City of Albuquerque

August, 1993

RE: GRADING & DRAINAGE PLAN FOR CUBBY HOLE VII (A-14/D4A3)
ENGINEER'S STAMP DATED 7-7-93; RECEIVED JULY 16, 1993
FOR FINAL PLAT & BUILDING PERMIT APPROVAL

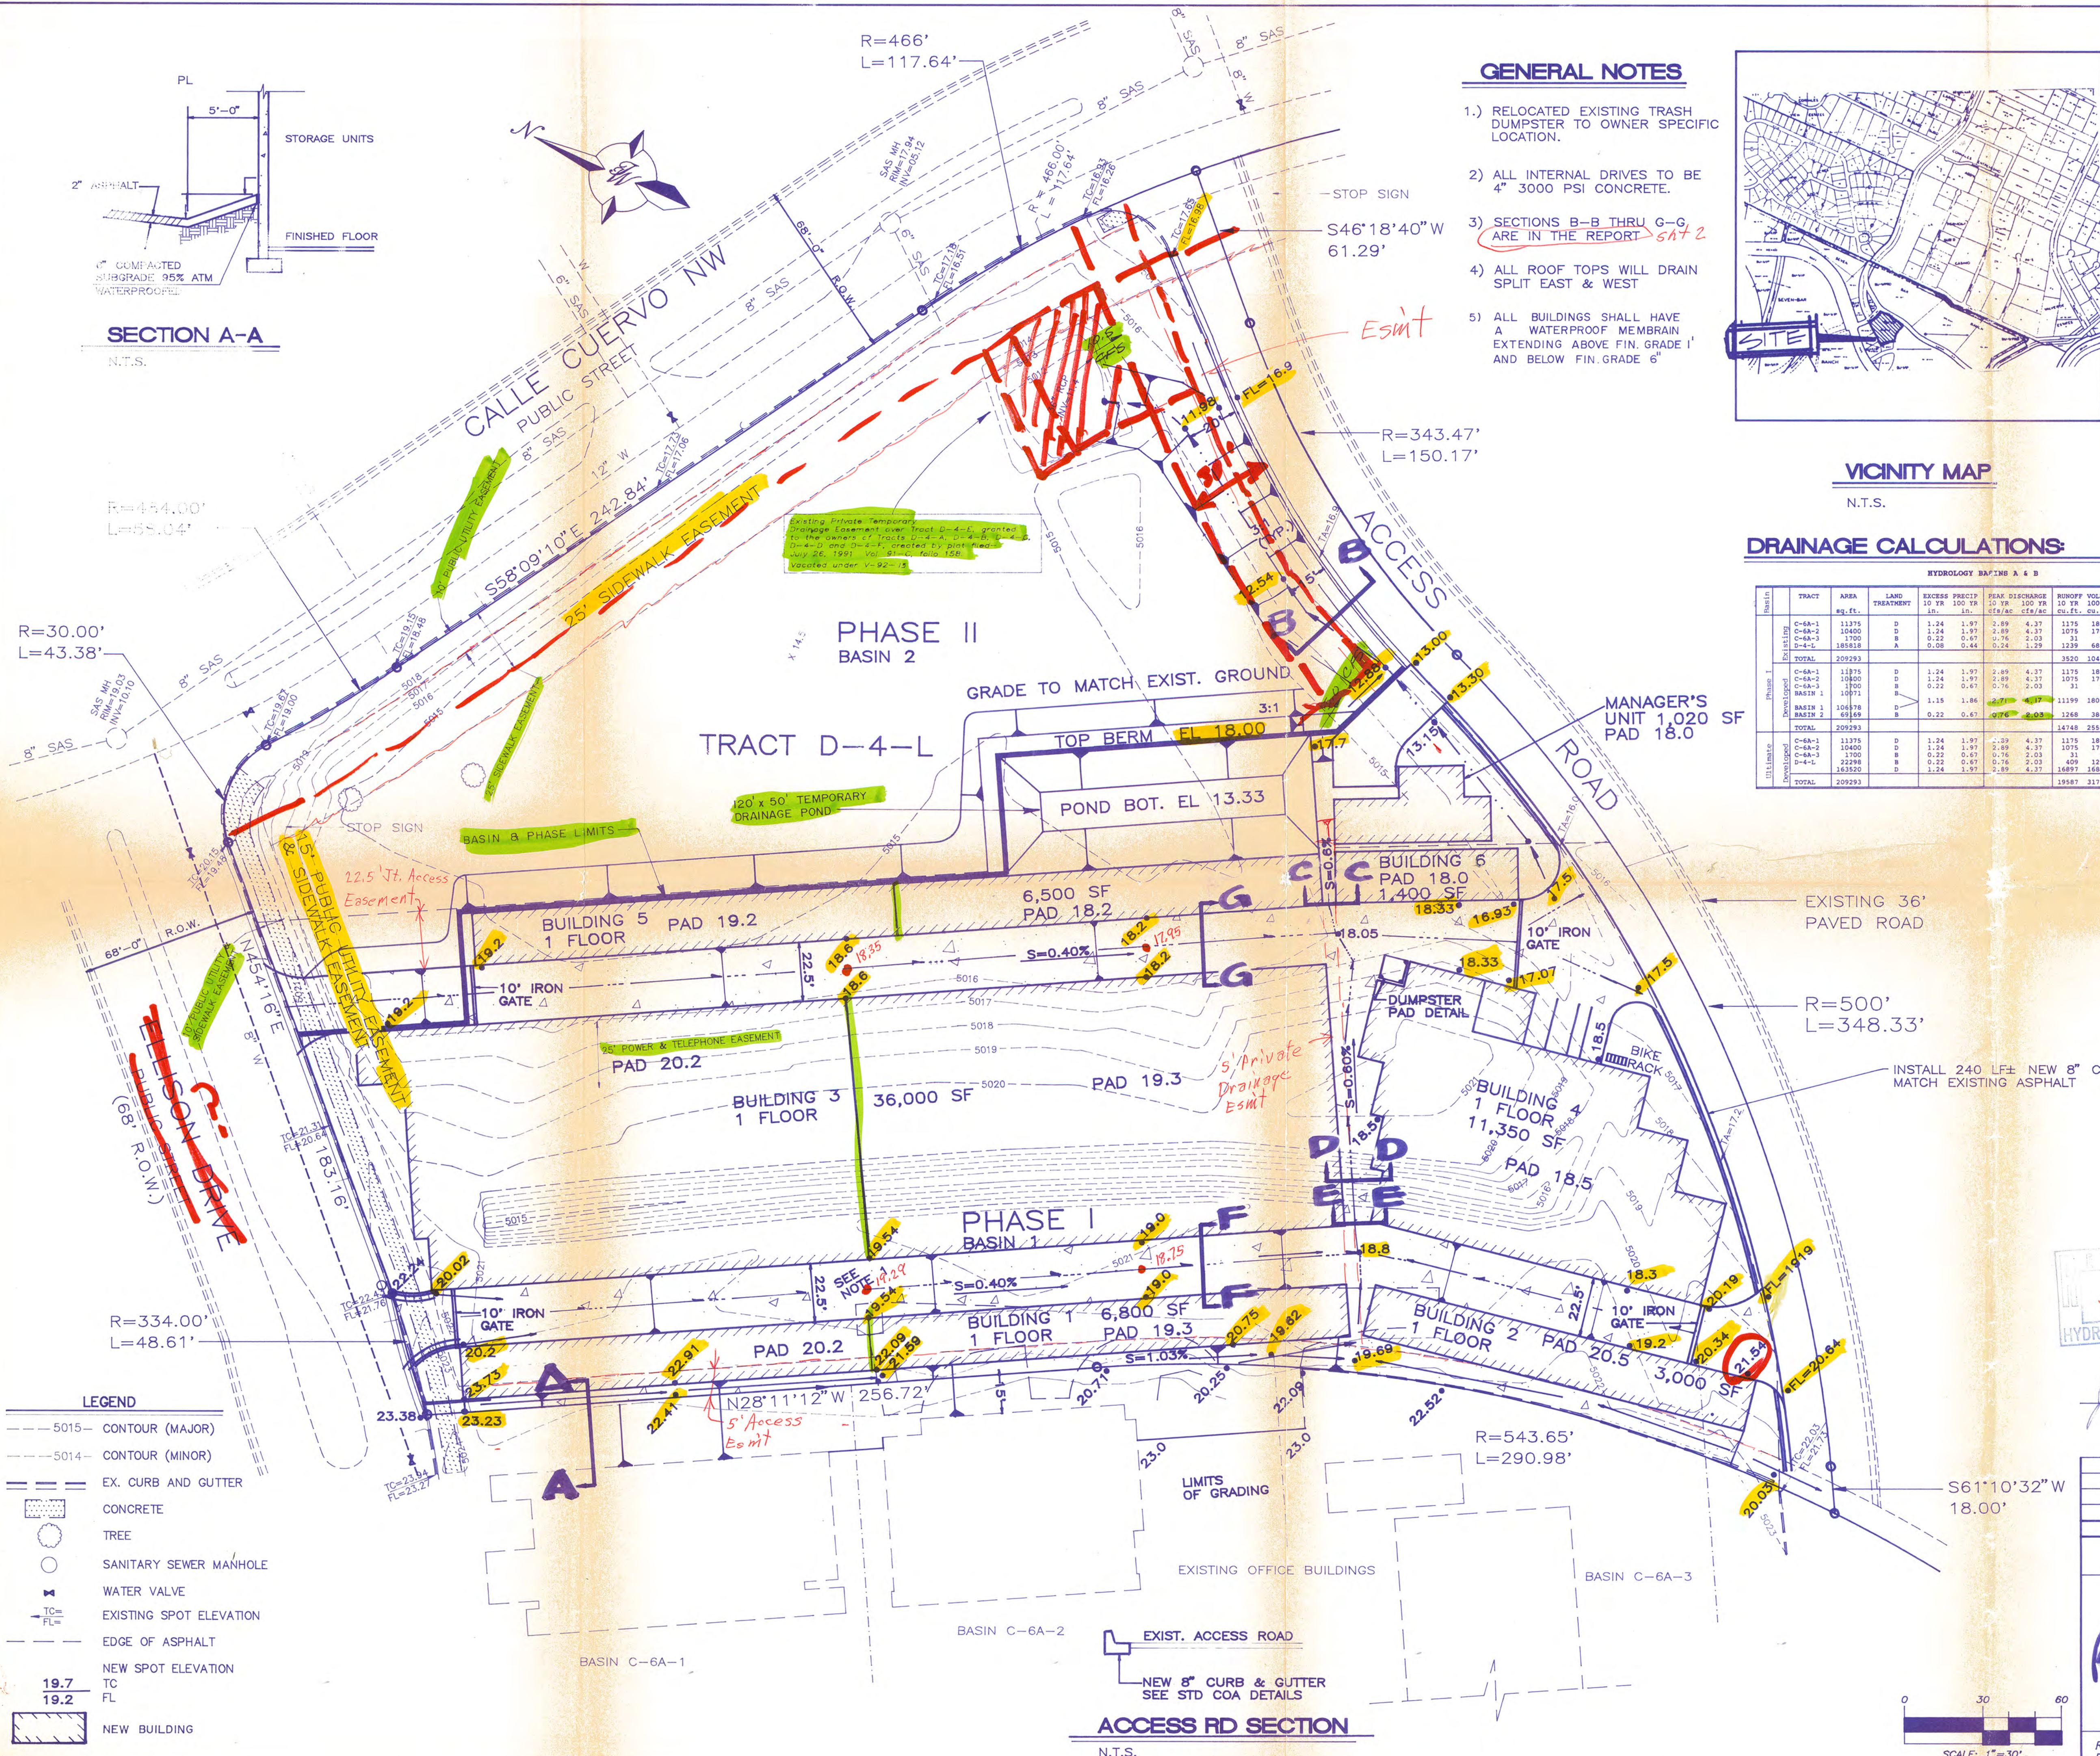
Based on the information included in the submittal referenced above, City Hydrology APPROVES this project for Building Permit.

Include a copy of the Grading & Drainage plan in the set of construction document submitted to the One Stop for Building Permit.

Engineer's Certification of grading & drainage per the DPM checklist must be approved before any Certificate of Occupancy will be released. Specifically all comments in the letter dated July 22, 1993 must be addressed.
